**Subject: COLUMBIA GENERATING STATION, DOCKET NO. 50-397
LICENSE AMENDMENT REQUEST IN SUPPORT OF DEPARTMENT OF
ENERGY (DOE) 618-11 WASTE BURIAL GROUND REMEDIATION
PROJECT – NON-INTRUSIVE ACTIVITIES**

**LICENSE AMENDMENT REQUEST IN SUPPORT OF DOE 618-11 WASTE BURIAL
GROUND REMEDIATION PROJECT – NON-INTRUSIVE ACTIVITIES**

Evaluation of Proposed Change

2.2.2.2. Des

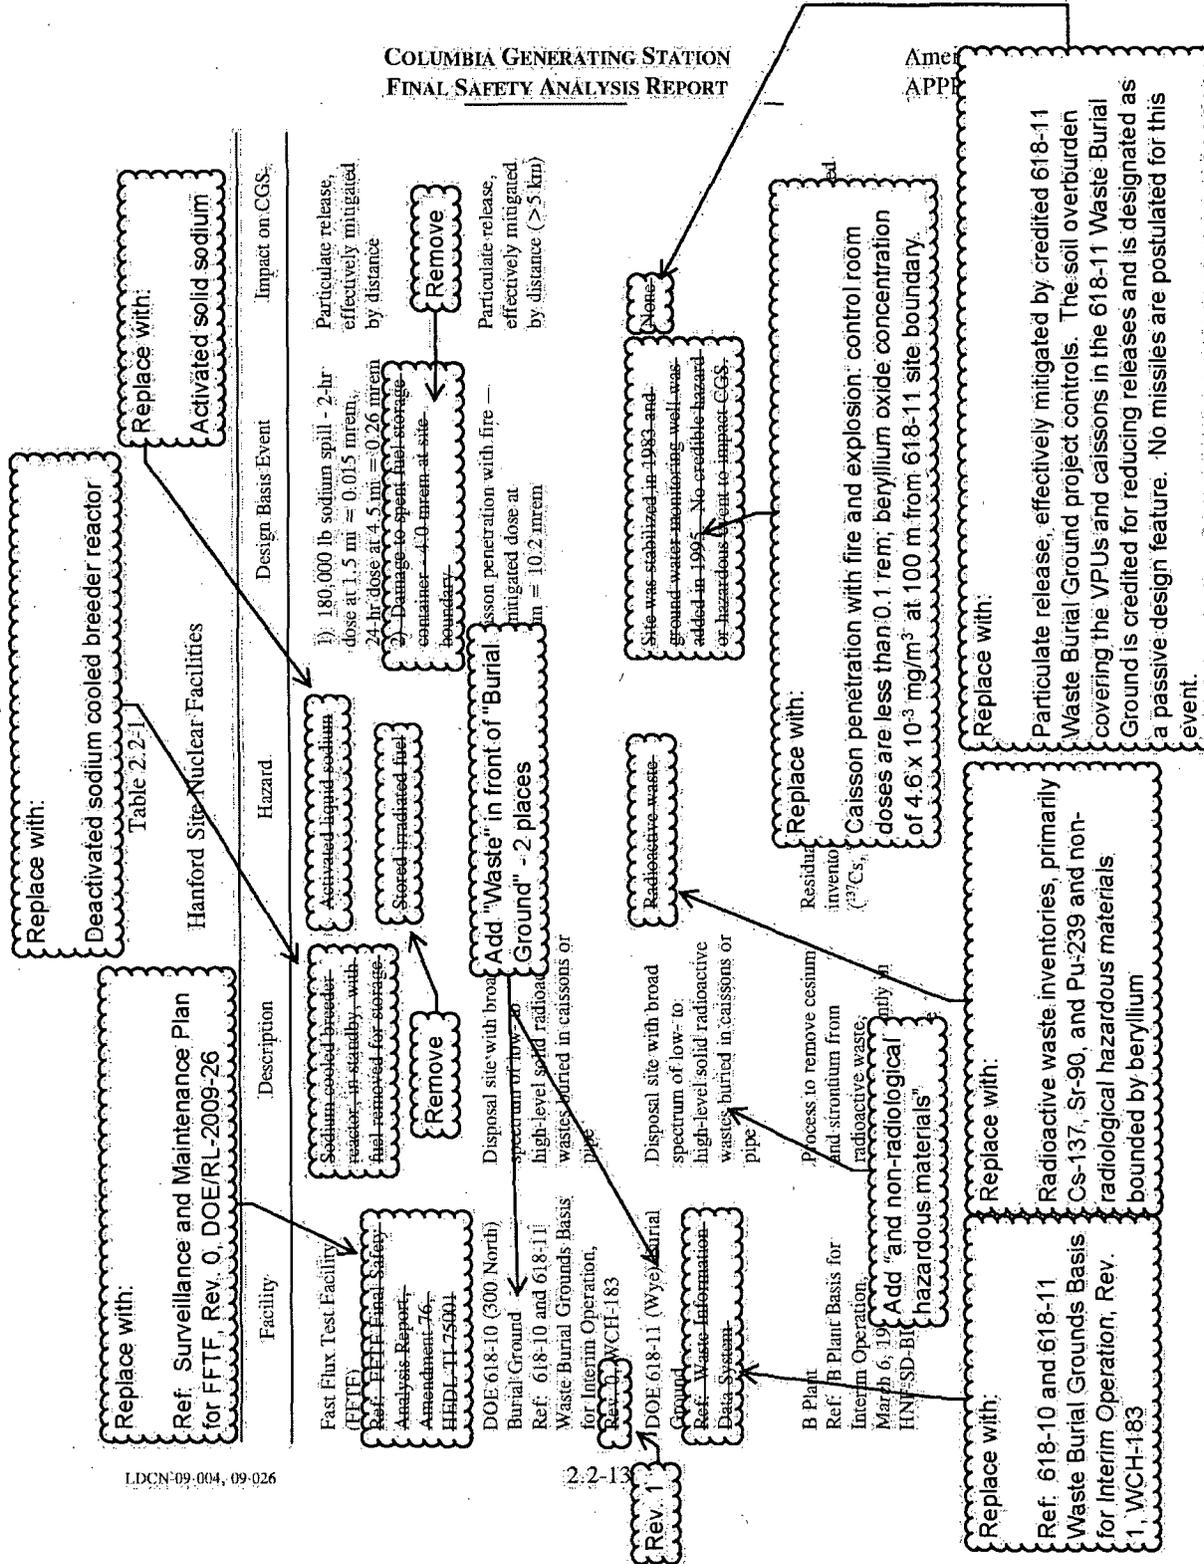
Three DOE facilities are located within a 5-mile radius of the plant site, the Fast Flux Test Facility (FFTF) and two radioactive waste burial grounds. The 618-11 (Wye) Burial Ground is immediately due west of the plant site. The other, 618-10 (300 North) Burial Ground, is approximately 3.5 miles south. FFTF is about 3 miles southwest of CGS.

The only hazard. Replace with:

Originally the
plutonium for
production to
change in miss
plant site and i

Three DOE facilities are located within a 5-mile radius of the plant site. These are the Fast Flux Test Facility (FFTF) and two radioactive waste burial grounds.

The specific hazards associated with these facilities are summarized in Table 2.2-1 and the specific activities are listed below:

- The 618-10 (300 North) Waste Burial Ground is approximately 3.5 miles south of CGS. DOE has initiated surveillance and characterization activities at the site to obtain data and information for planning remediation strategies.
